October 11, 2019

Re: Staybridge Colfax  
Response to Pre-Application Notes

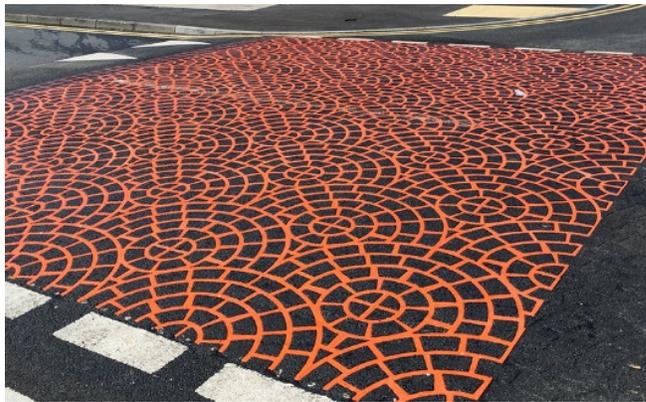
City design standards call for an urban streetscape along both Colfax Avenue. This should include a 16-foot urban sidewalk with tree openings. The existing sidewalks should be widened / improved to comply with this requirement. Colored pavers shall be installed between the tree openings per the Fitzsimons Boundary Area Public Realm Design Standards. Site furnishings, such as trash receptacles, bicycle racks, and benches, shall also be provided in this area per the Fitzsimons Boundary Area Public Realm Design Standards.

**RESPONSE:** The Proposed streetscape has been designed as noted above.
